Review of
Water-Related Aspects of the Mt Todd Gold
Project Draft Environmental Impact Statement

Report C2/13

Northern Territory Environment Protection Agency

August 24, 2013

Figure 24-1 Waste Rock Dump Design

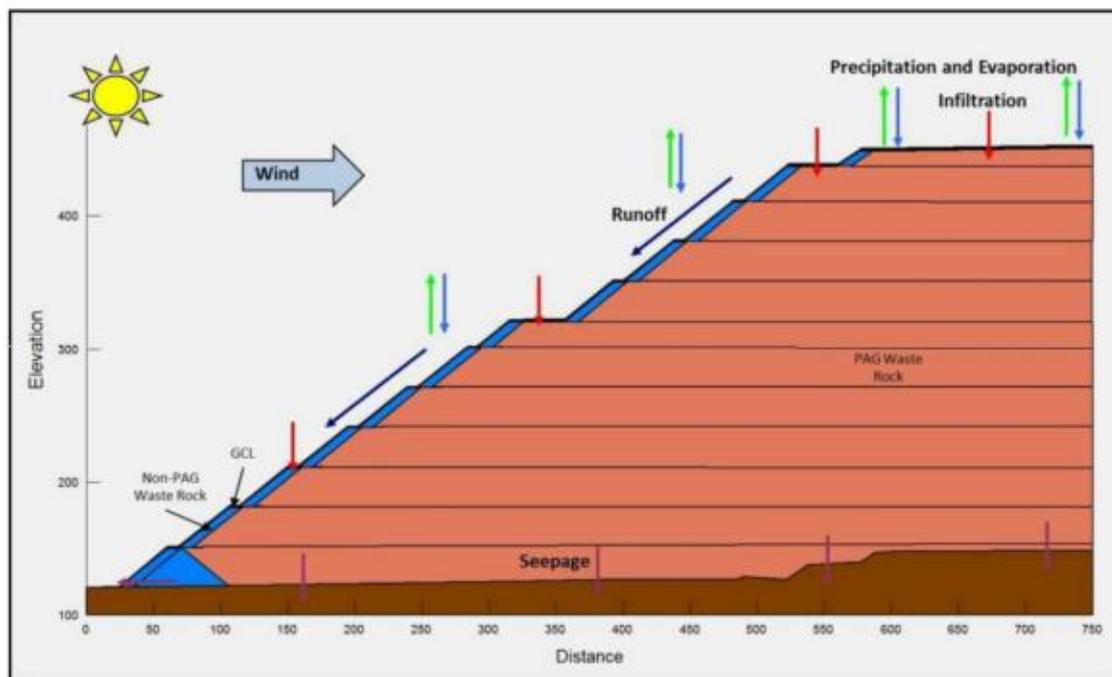
Comment in this report will be restricted to issues of potential water-related environmental risk associated with the proposed design, not economic or practical matters related to construction of such a large elevated structure.

The major issues that need to be addressed in the context of environment risk through operations and closure are: (1) the method of construction during the operational period and how that will mitigate potential for AMD generation, (2) the final cover design, (3) geotechnical stability over the long term, and (4) landform geomorphic (erosional) stability over the long term. All of these factors need to be appropriately addressed upfront given that once the structure is built it will not be possible to retrospectively address major performance shortfalls.

The existing WRD will essentially be buried within the new WRD which will extend upgradient between RP1 and the Pit. In this context it should be noted that the WRD will be built over the alluvial channel of a former creek alignment. The existence of this lateral under-draining path is likely one of the pathways facilitating transport of ARD to RP1. Reducing this flow pathway should be addressed as part of the design for the proposed WRD.

It is now well known that the technique of end dumping for building up a waste rock dump increases the likelihood of AMD generation and transport, by virtue of the creation of preferred pathways for the transport of both oxygen and water. It is requested that the proponent provide information in the Supplement to the EIS about how it is planned to construct this dump and, in particular, how the wetting up of the dump and exposure to oxygen will be minimised during its construction. Related to this will be how the flow of water across and down the faces of the dump will be managed since this will substantively impact on the water management and treatment system during the operations period. Whilst the management of water flows has at least been partly explained for the final landform surface, this was not the case for the operational period.

Placement of a 10m layer on non-PAG rock along the front face of the bench has been proposed as the strategy to encapsulate the bulk PAG rock. However, it has not been explained if this cover will be placed in tandem with the construction of each bench lift or whether this will be placed at a later time. Best practice for AMD dump construction recommends that compaction be periodically carried out to limit infiltration during the construction phase, and that the surface should be sloped to maximise runoff and minimise surface ponding. Another (geochemical) control strategy is the installation between benches of a layer of neutralising material – eg limestone- that functions as a horizontal reactive barrier. These strategies would actively mitigate water quality risk during both the operational and through the post closure period for this proposed structure.

It is proposed in the EIS that a GCL-based cover will be used for the surface of the WRD. This is a very significant change from the originally proposed store and release cover (Jan 2011 PFS). It is requested that the proponent provide the reason for this change since it will have a substantive bearing on how the cover will interact with both the physical and biological environment. In particular, it is likely that a store and release cover can better accommodate the effects of differential vertical consolidation, which is likely to be substantial through a 350m profile of uncompacted waste rock. The performance of a store and release cover relies on evaporation via the roots of vegetation. In contrast the performance of a GCL-based cover could be substantively compromised by root penetration. The proponent should provide evidence of the successful long term implementation of a GCL-based cover system in a similar climate regime and, as recommended above, undertake predictive performance modelling incorporating the effects of climate variability.

The issue specifically refers to the impact of vertical consolidation and/or slope failures on the integrity of the structure. The possible effect of consolidation has already been referred to above for the final surface cover of the dump. This could also be an important issue for the effectiveness of the planned inter-bench GCL layer, which will depend on the maintenance of a slight (5 degree) downward slope to direct seepage to the outer dump face. Whilst the proposed design might look good in static 2D cross section, the potential for failure of this important control strategy should be assessed by consolidation modelling of the rock mass.

The second aspect of geotechnical stability relates to the possibility of failure at the toes of the benches. Indeed the use of a GCL layer to intercept and direct seepage along the inter-bench plain could substantively increase this risk. It is thus requested that a slope stability analysis be performed under saturated conditions (along the surface of the interbench GCL) to assess the factor of safety of the proposed design.

Recommendation 6: The proponent provide substantially more detail about the construction of the waste rock dump with emphasis on incorporating best practice strategies to mitigate as far as practicable the future AMD risk of this structure.

Recommendation 7: The proponent provide justification for the change from a store and release cover to a GCL-based cover since it will have a substantive bearing on how the cover will interact with both the physical and biological environment.

Recommendation 8: The proponent should provide evidence of the successful long term implementation of a GCL-based cover system in a similar climate regime and, as recommended above, undertake predictive performance modelling incorporating the effects of climate variability.

Recommendation 9: The proponent undertakes consolidation modelling to assess the structural viability of the proposed interbench GCL seepage interception layer, and the physical viability of the proposed GCL-based surface cover.

Recommendation 10: The proponent undertakes slope failure modelling to assess the effect of the proposed inter-bench GCL seepage interception layer on the long term stability of the structure.

Recommendation 11: The proponent should test the proposed design (including catchment and drainage structures) with a well-regarded and tested 3D event-based computer geomorphic model.
